Heritage

KMR.CDD.NaQ.1918-1919.02

With reference to his application dated 29th ultimo with plans for the proposed additions and alterations on plot No. 69, A-26 Napier Quarter Mr. Khinji Hari owner of the above plot is referred to No. L.S. 1119 dated 7th ultimo and informed that the same objections still hold good and the permission for erecting further building on the plot cannot be granted.

With reference to his application dated 20th ultimo with plan regarding the proposed additions and alterations on plot No. 69, A-26 Napier Quarter Mr. Khimji Hari owner of the above plot is informed that the existing building is in a most insanitary state and the plot is overcrowded. Permission to erect further building on the plot will not be allowed.

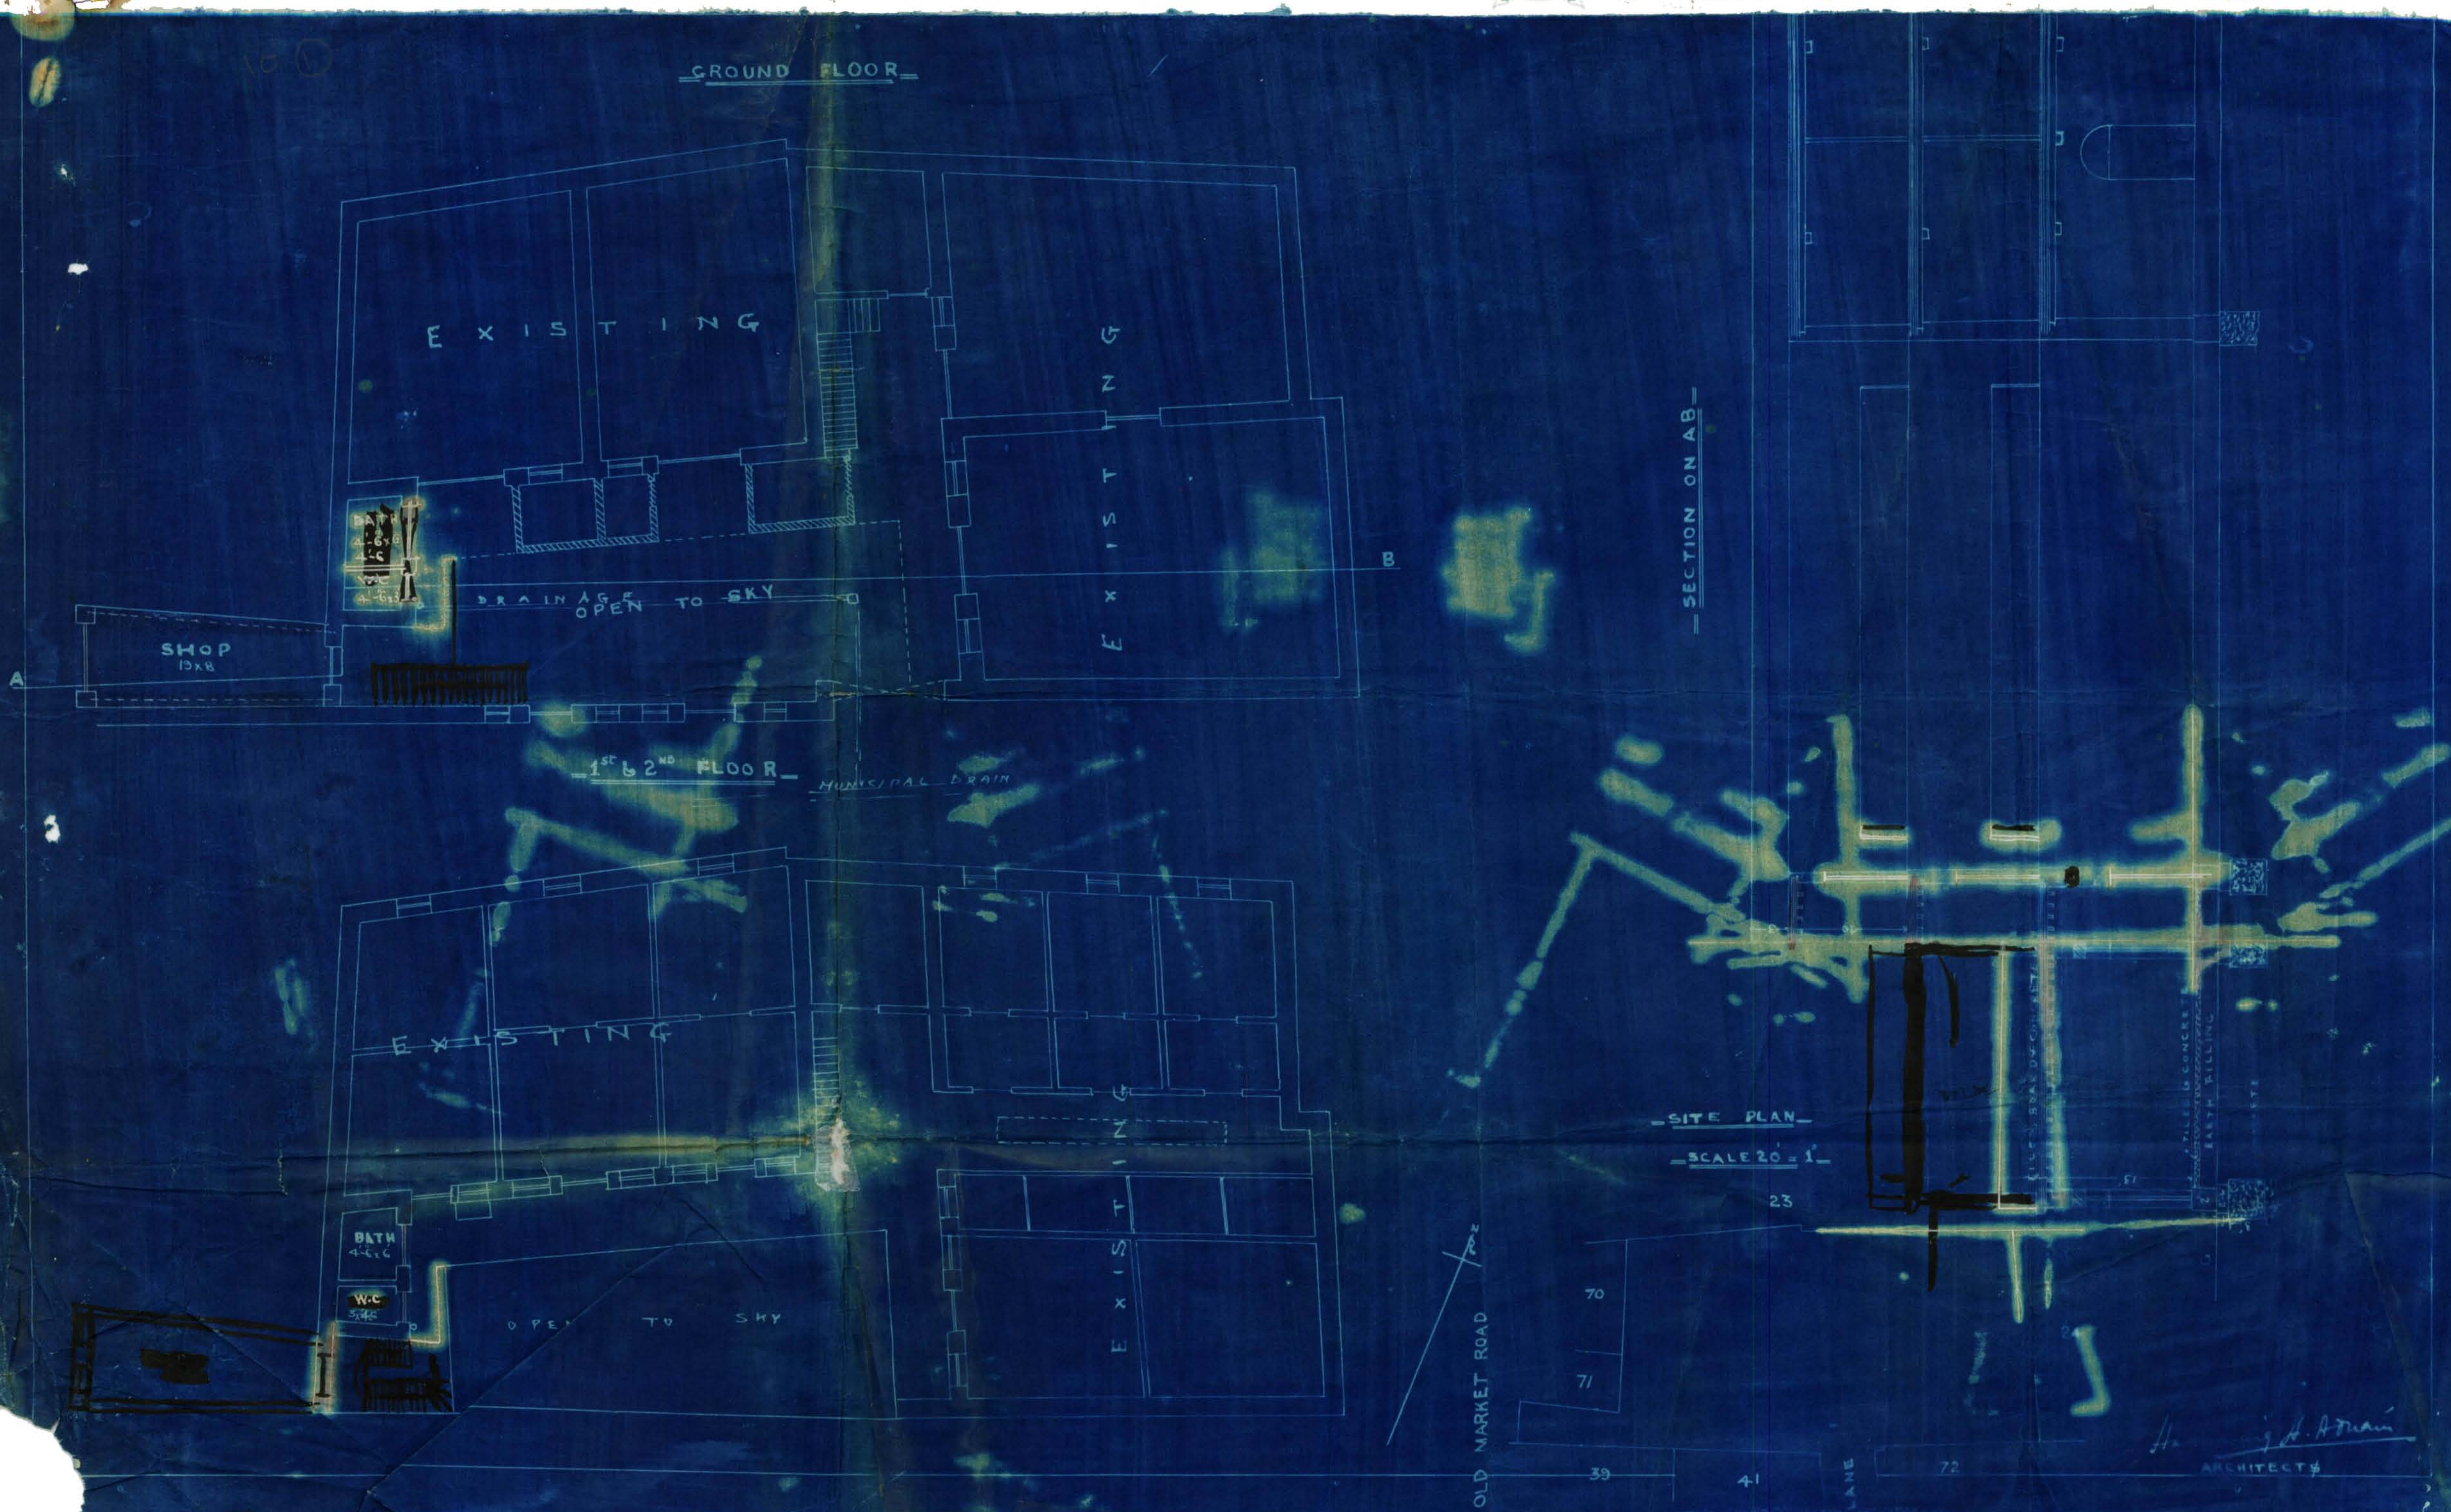
Returned with the report
that the plot is already
overcrowded.

2/ The other owners of the
plot object to the erection of the
new shop & hence the plan
cannot be adopted.

A 26
69 Napier 2nd

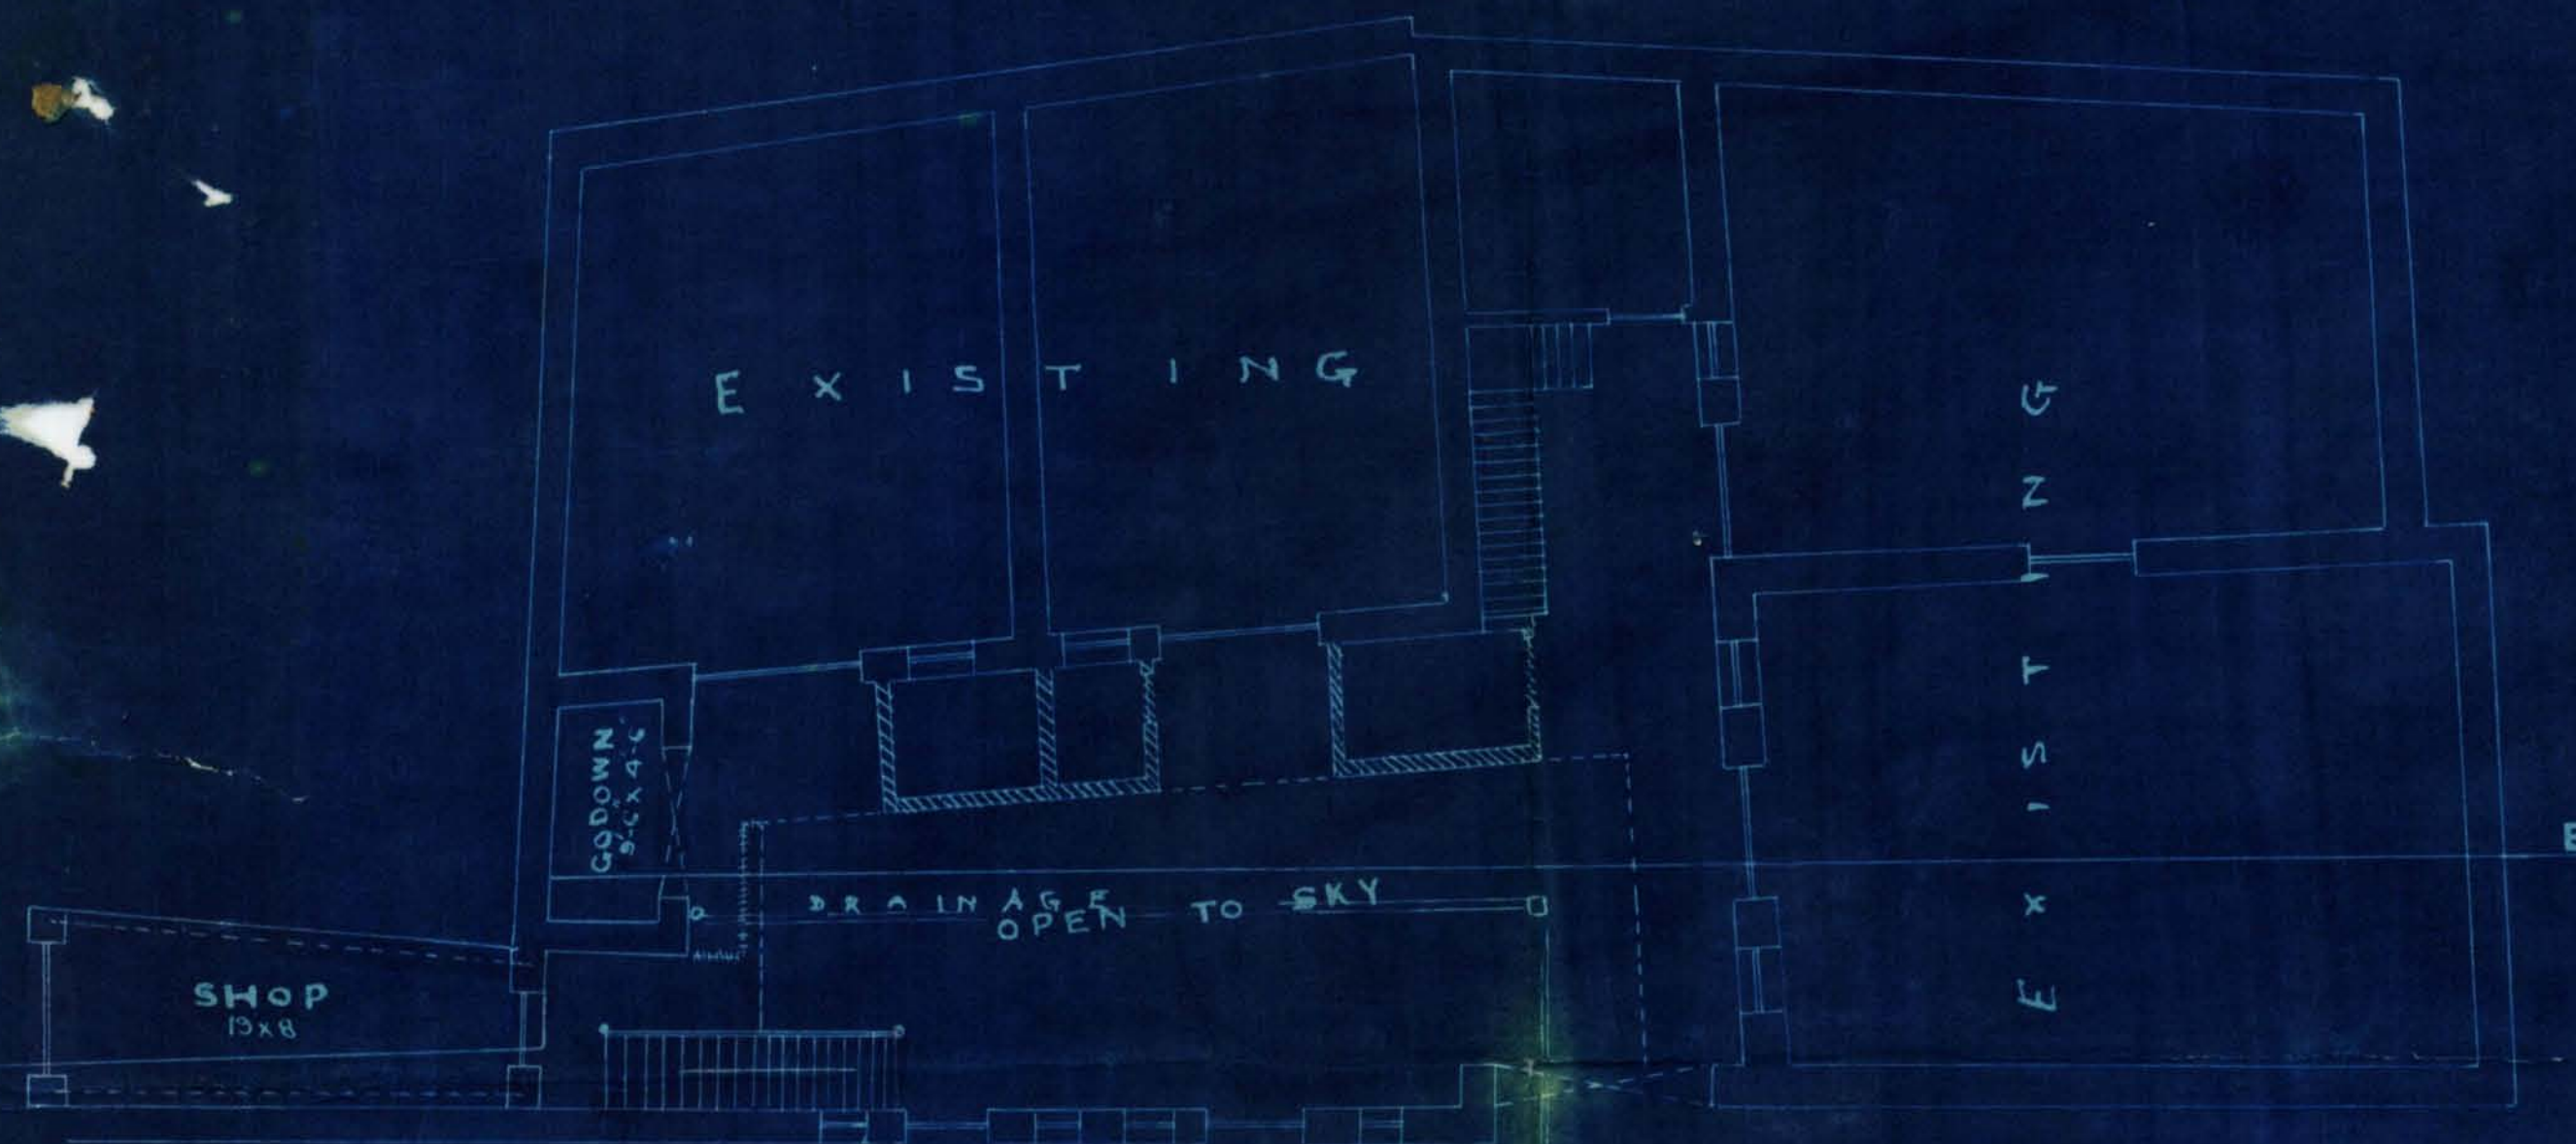
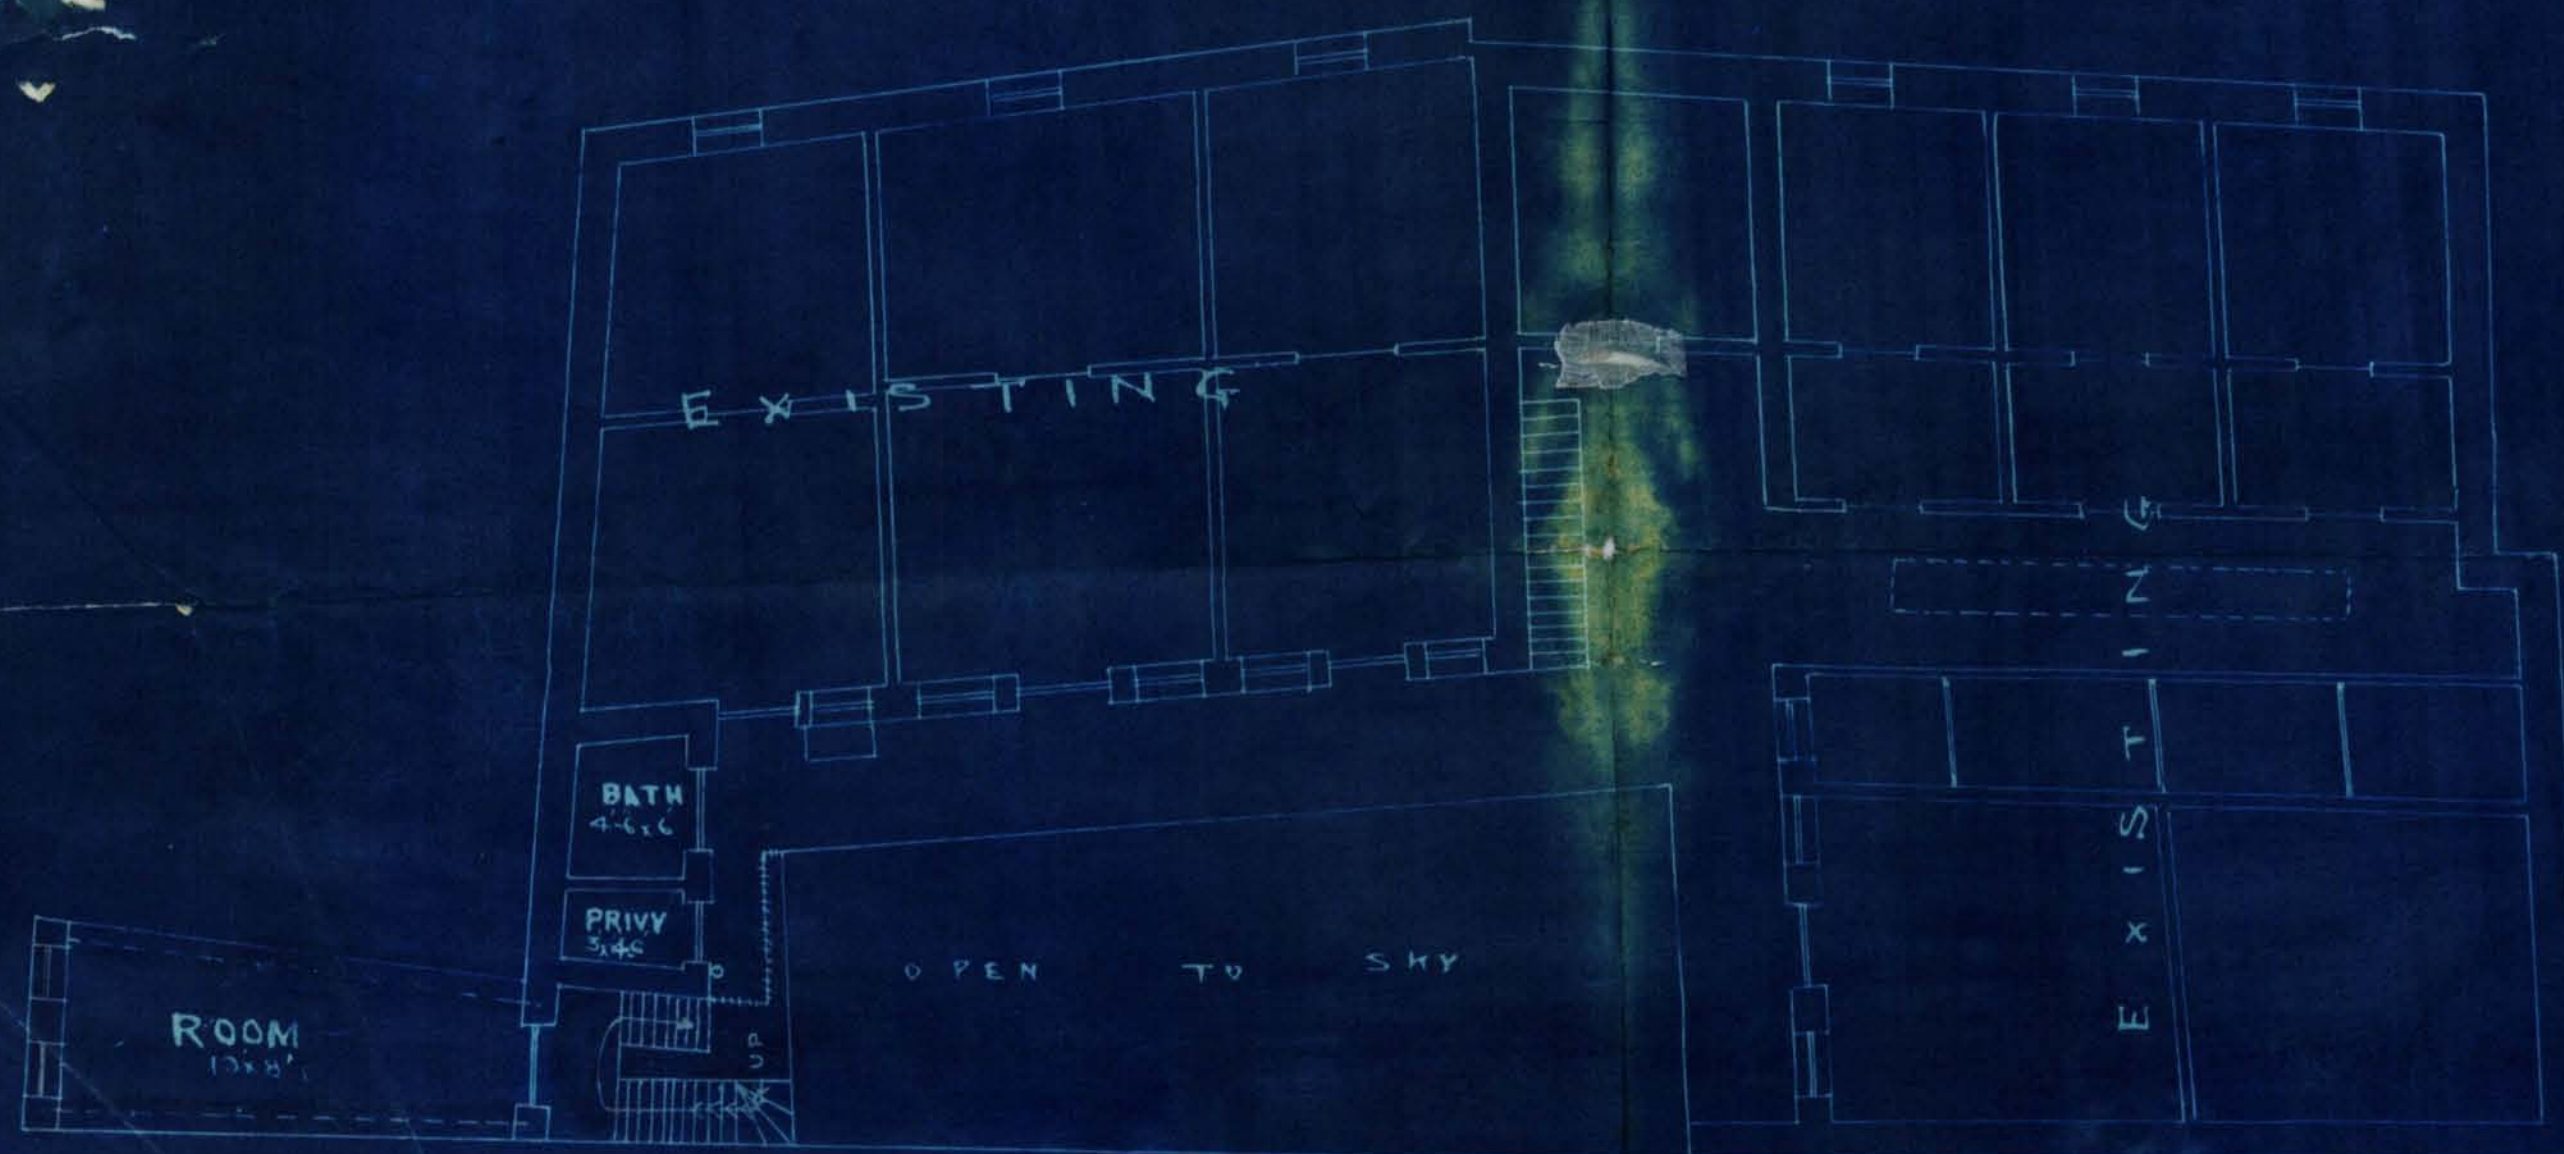
The existing building is in a high insanitary condition and the owner is served with notices by this dept. to have repair, finished in the building & premises. Until he complies with the orders, the plan cannot be considered as otherwise it would add more to the insanitary condition. The owner is personally informed accordingly by us.

Building Surveyor's Report Sir, with reference to this I report
that the area of the plot is already overcrowded &
from the construction of a shop etc cannot be recommended. The
present outlet to Old Market Road is essential for the
tenants. The ^{new} Godown on the ground floor is a fiery block.
The no of Sanitary Conveniences for 12 families on each floor
is very inadequate. The place is most insanitary.
 Date 26/2/1919 Very obediently
 Building Surveyor.

Remarks Sir, with reference to this I report
that nothing could be done till the
Health Officer's orders are carried out
the existing building is most insanitary
of material
W. H. H.

The existing building is in a most
insanitary state & the plot is overcrowded.
Permission to erect further building on
the plot will not be allowed. This plan
is disapproved.
